Access Compliance Report

Public Rights-of-Way

(Curb Ramps)

Intersection ID: 43685	Main Street: HARLINGTON_LN	Cross Street: TODDINGTON_LN	Location:	NE
ADA ID: 8BB18F5EF50F	Ramp Type: BlendTrans1	Initial Pass/Fail: Fail	Overall Compliance: No	Severity Score: 10
Codes/Mitigation Info/Possible Solution		Field Measurements/Component Compliance

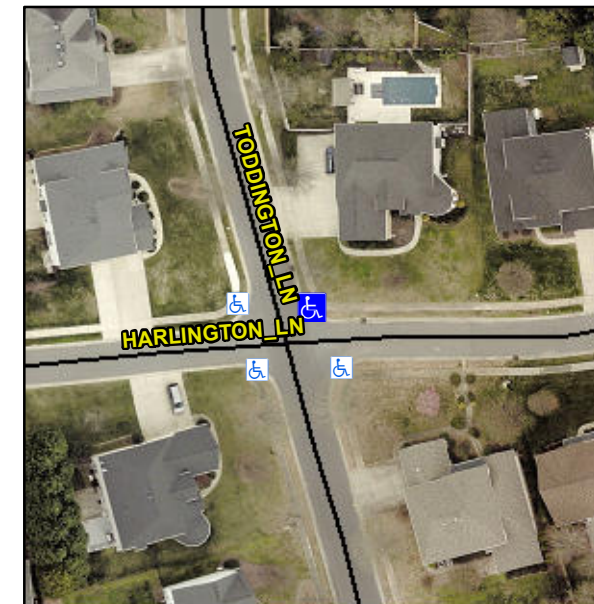
Not Found, R304.5.1, R304.5.3

Compliance	Description	Data	Compliance	Description	Data
N/A	Ramp Length (in)	44.0	Yes	BlendTrans Slope (%)	3.1
No	Ramp Width (in)	46.0	No	BlendTrans XSlope (%)	2.3
N/A	Flare Type LT	N/A	N/A	Flare Type RT	N/A
N/A	Flare Slope LT (%)	N/A	N/A	Flare Slope RT (%)	N/A
N/A	Flare Traversable LT?	N/A	N/A	Flare Traversable RT?	N/A
N/A	Landing Length (in)	N/A	N/A	DWS Provided?	N/A
N/A	Landing Width (in)	N/A	N/A	DWS Contrast?	N/A
N/A	Landing Slope (%)	N/A	N/A	DWS Length (in)	N/A
N/A	Landing X Slope (%)	N/A	N/A	DWS Full Width?	N/A
N/A	Landing Curb? (Y/N)	N/A	N/A	DWS Offset (in)	N/A
N/A	Shared Landing?	N/A			
N/A	Gutter Ponding?	N/A	N/A	Gutter Slope (%)	N/A
N/A	Gutter Lip Ht (in)	N/A	N/A	Gutter X Slope (%)	N/A
N/A	Painted X Walk1?	No	N/A	Painted X Walk2?	No
	X Walk 1 Direction	To W		X Walk 2 Direction	To S
	X Walk 1 Width (in)	N/A		X Walk 2 Width (in)	N/A
	X Walk 1 Slope (%)	1.2		X Walk 2 Slope (%)	0.8
	X Walk 1 X Slope (%)	2.0		X Walk 2 X Slope (%)	0.3

N/A	Ramp inside XWalk1?	N/A	N/A	Ramp inside XWalk2?	N/A
	Road Slope (%)	2.7		Clear Space?	N/A
	Road X Slope (%)	1.0	N/A	Clear Space to XWalk (in)	N/A
N/A	Any Obstructions?	N/A	N/A	Storm Grate/Utility Hazard?	N/A
	Obstruction Type			Storm Grate/Utility Type	
		N/A			N/A
			Yes	Surface Condition? (G/P)	Good
			No	Curb Slope (%)	9.5

Remove & Replace Curb Ramp With Two New Directional Ramps or Equivalent.
